REFERENCE: RECON 26/0234

PROPOSAL: PROPOSED NEW AGRICULTURAL ACCESS TO SERVICE
EXISTING FARM BUILDINGS AND FARM HOLDING

SITE: Pen Y Groes Penylan Road Bassaleg Newport NP10 8RW

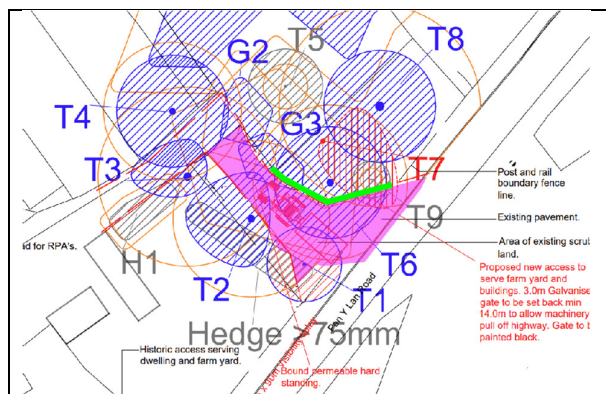
The hedge planting shown on the soft landscape plan may not be very successful under the beech canopy of T6 [refer my approximate overlay below], the mix includes alder whereas a higher percentage of natural understorey species such as holly may be more successful.
